**PRE-DESIGN TECHNICAL MEMORANDUM**  
**MADRID STORMWATER AND EROSION SAFETY PROJECT**

SHARE No. 19-521-0620-0160  
Task Order No. 1

August 1, 2019

## **PRE-DESIGN TECHNICAL MEMORANDUM MADRID STORMWATER AND EROSION SAFETY PROJECT**

Figure A-1. East Slope Sub-Basins

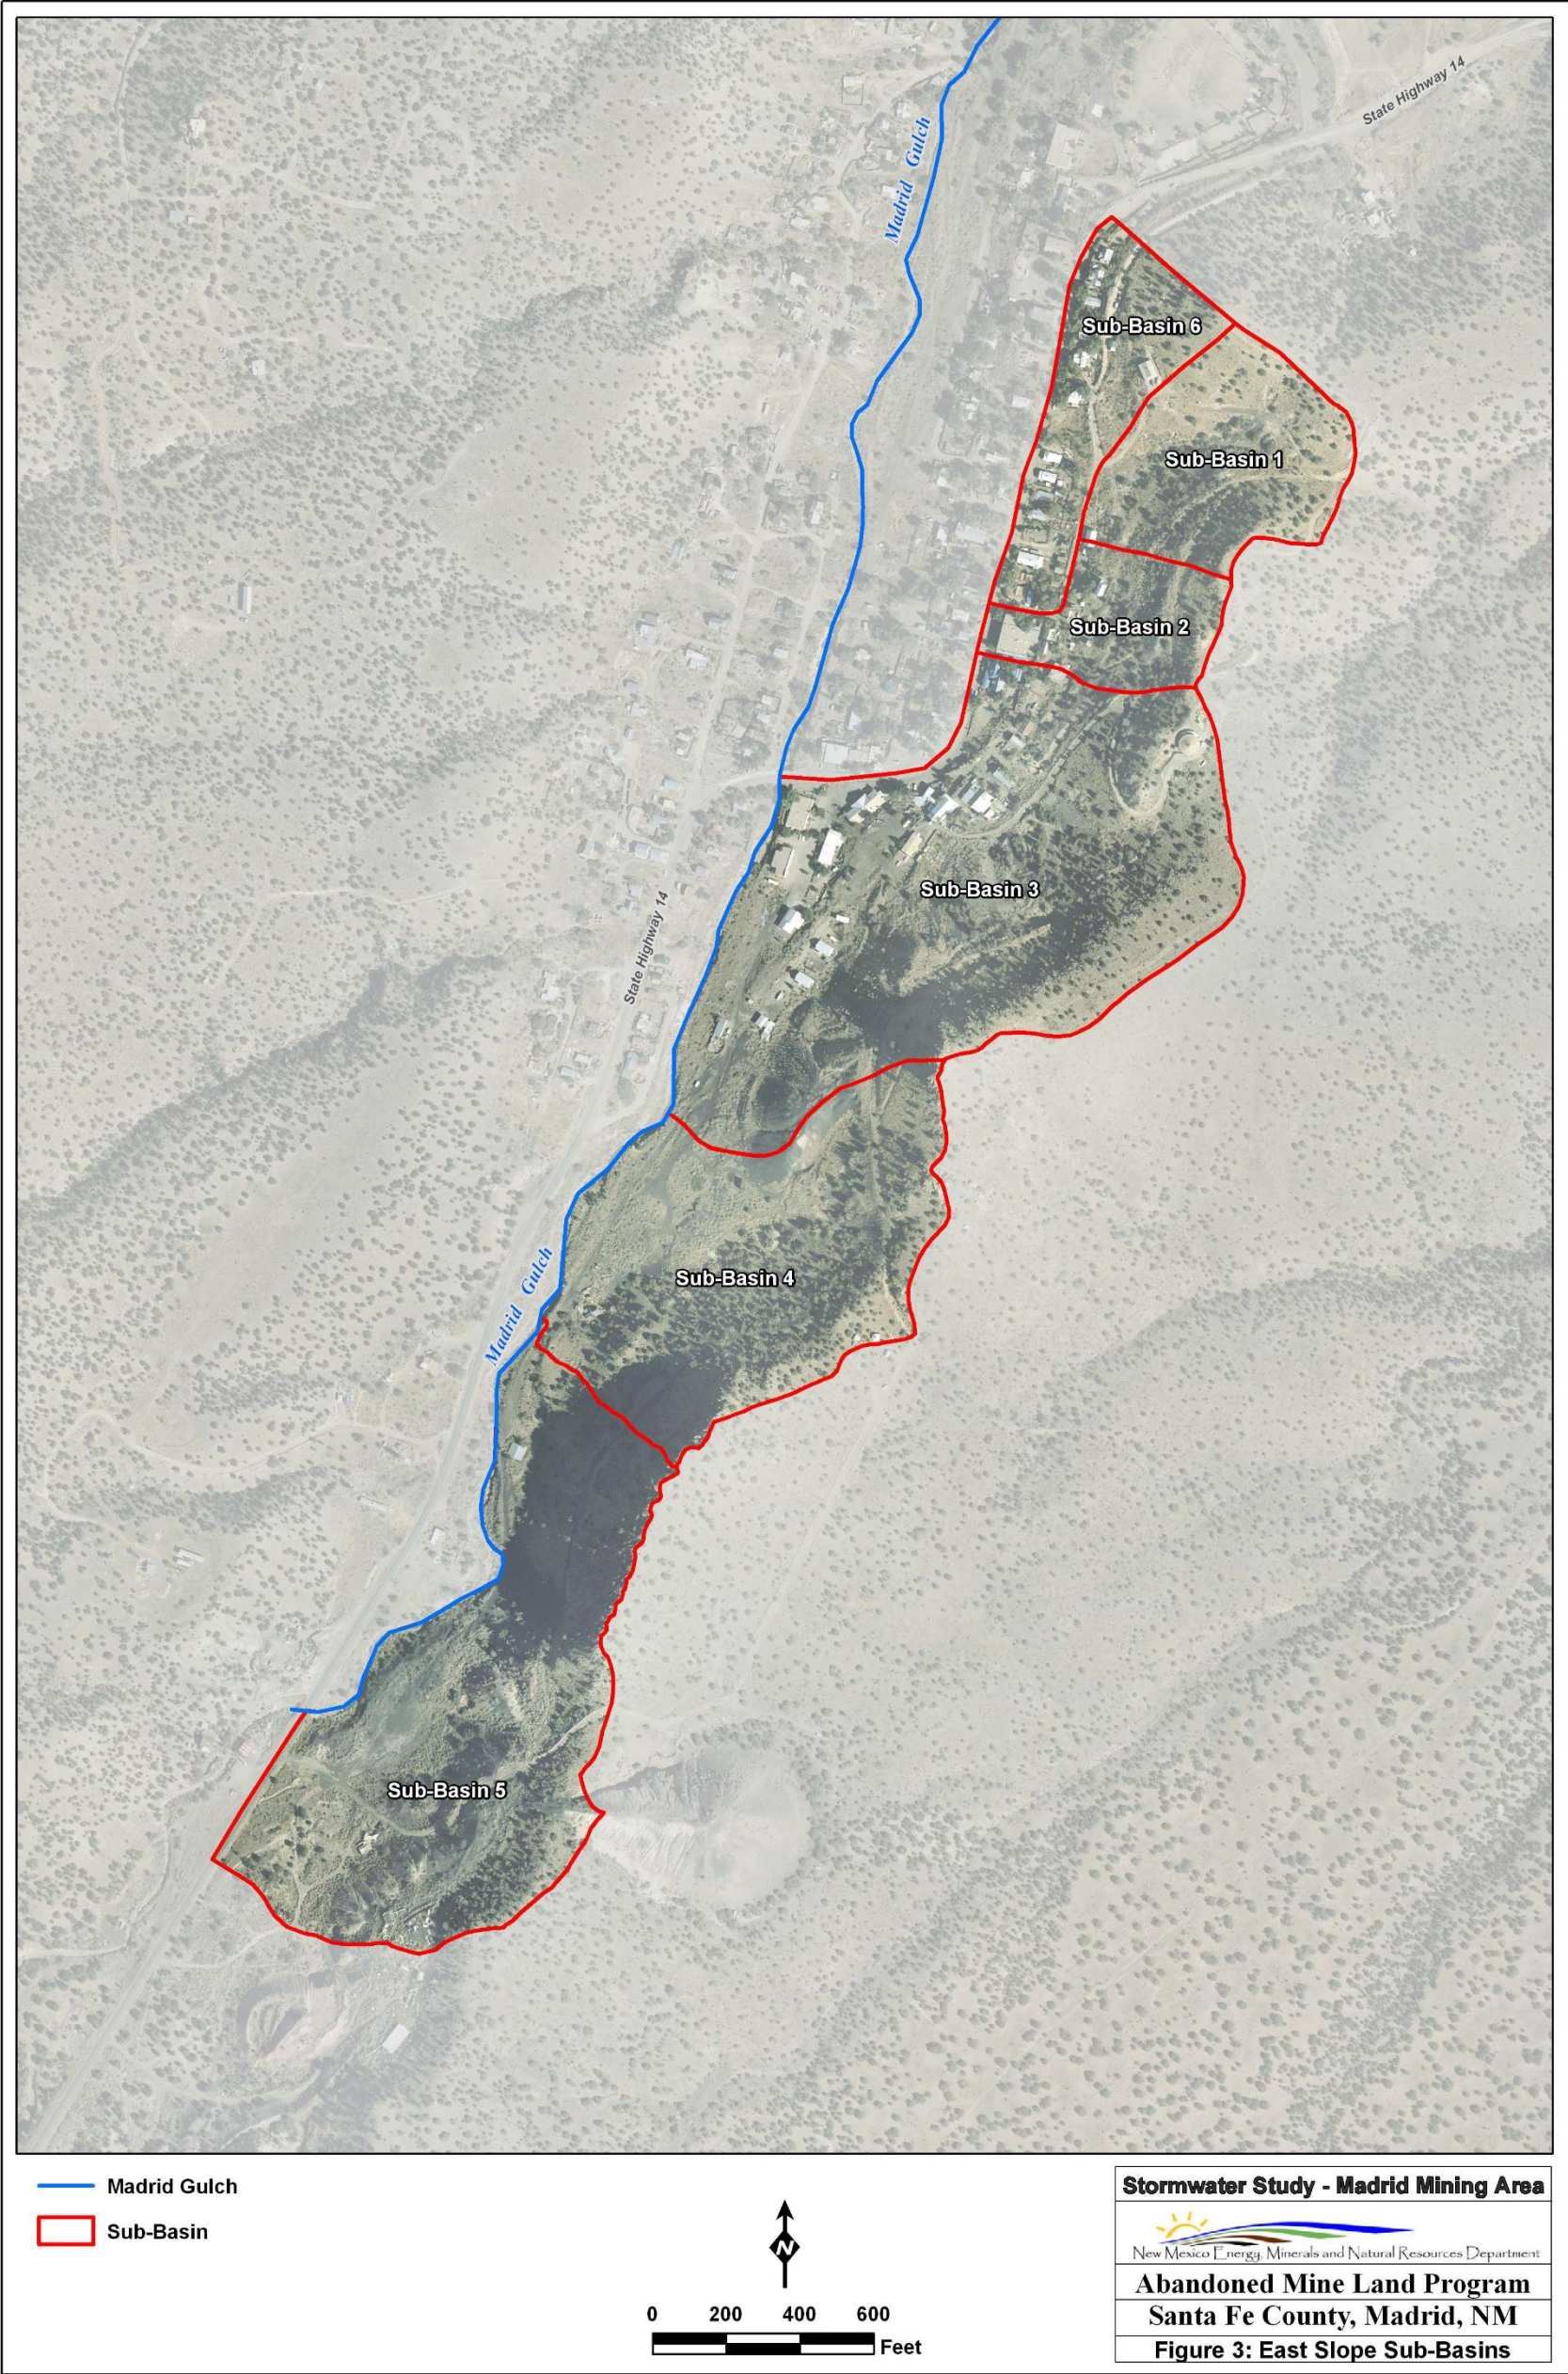
The report proposed detention ponds to control drainage from Sub-Basins 1, 3 and 6 (See Figure A-1) and was sized to contain the 100-year stormwater flow. Detention ponds would be located at the terminus of the defined natural channel created in Sub-basin 1 and a new channel that routed towards Firehouse Lane (Sub-basin 3).

Considerations: Detention pond options were not a preferable solution to Santa Fe County and rejected from further consideration. However, detention ponds are considered a viable option when considering stormwater control and infiltration. They may be needed if it necessary to control the flow entering existing drainage structures such as the crossing under Highway 14 or to control sediment.

The detention pond proposed near Firehouse Lane would control the water entering Madrid Arroyo and trap sediment. The detention pond could reduce the flow entering Firehouse Lane if it was located further upland and used as part of the diversion system.

Figure A-3. Proposed Ice House Road Drainage Channels

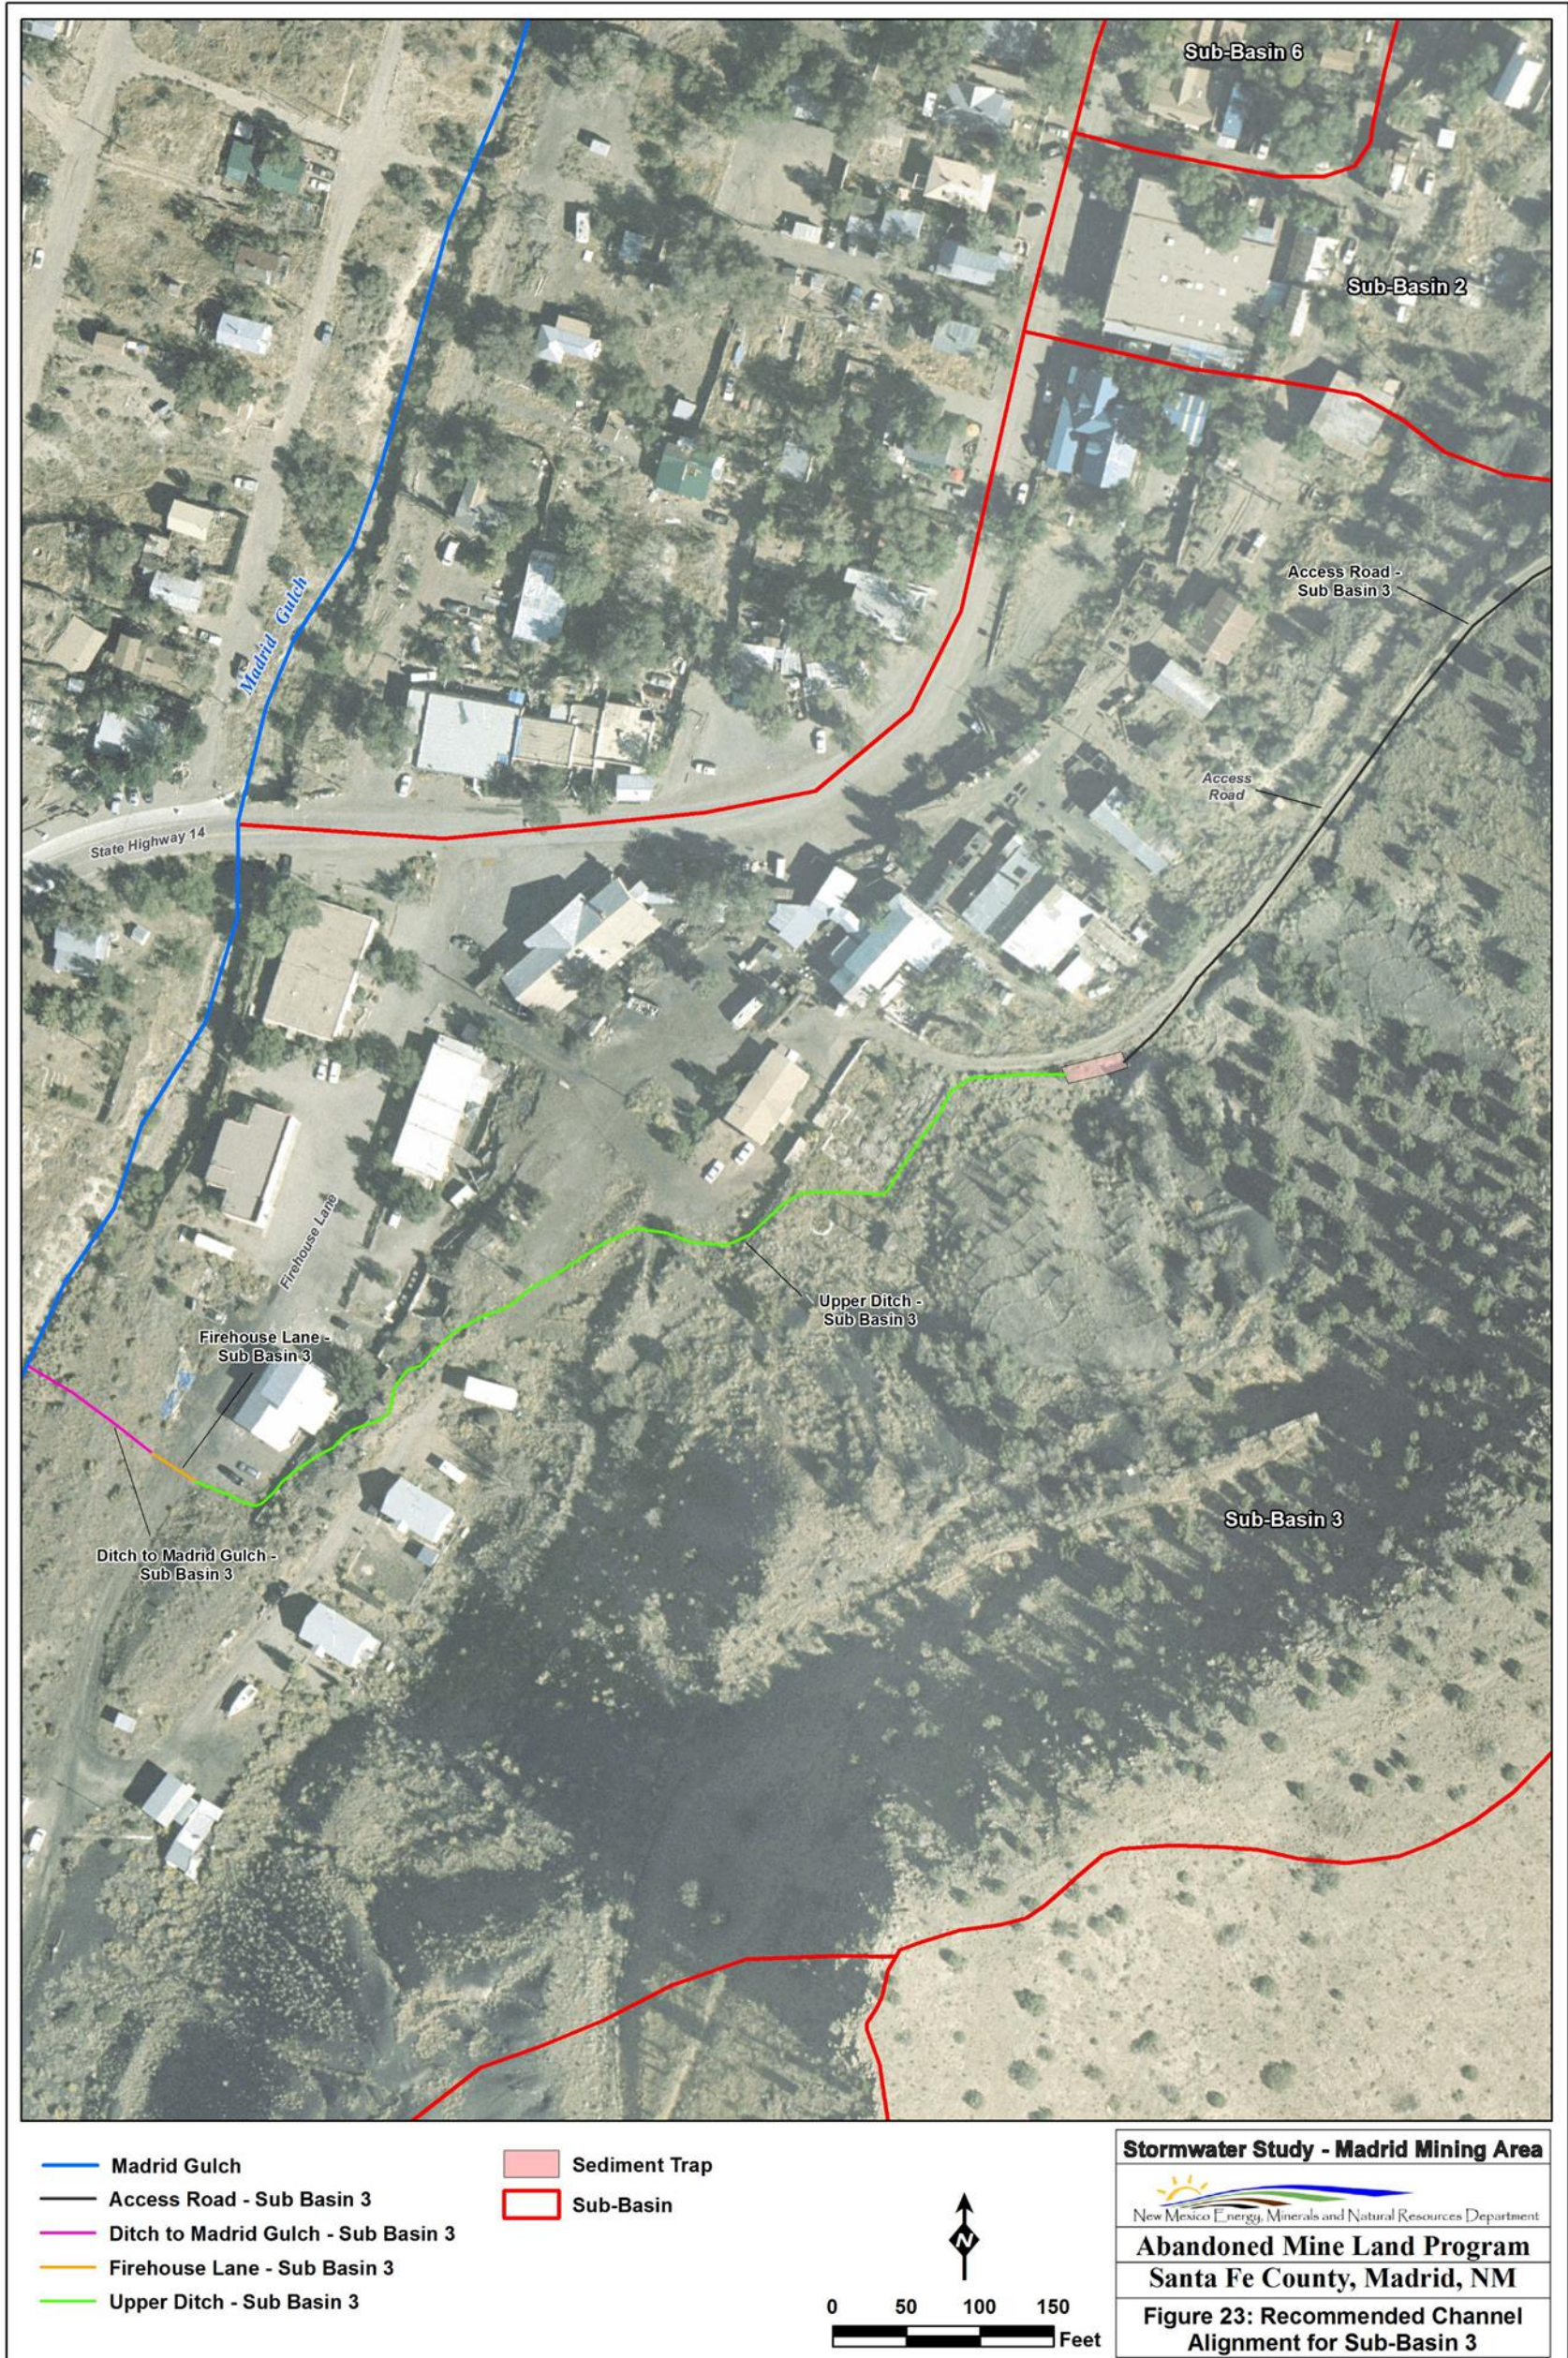
**Ice House Road Drainage Channel (Sub-basins 1, 2 and 6).** A proposed ditch along Ice House Road would convey the runoff away from homes below Ice House Road that are subject to flooding. One alternative was a ditch located along Ice House Road and another was to create a more defined ditch along the established flow path that travels under NM 14. Although the drainage ditch was rejected due to limited easement space, modifications to the conceptual design that incorporate an inverted crown road and/or storm drains would divert runoff away from the homes below Ice House Road.

The Ice House Road drainage channel was proposed to convey the 100-year flows from sub-basins 1, 2, and 6. It requires construction of a trapezoidal channel with a 12-foot bottom width graded at a 0.01 ft/ft slope to the west that follows the natural slope of the east slope drainage area. The channel would be designed to allow for vehicle use (*ie.* inverted crown road).
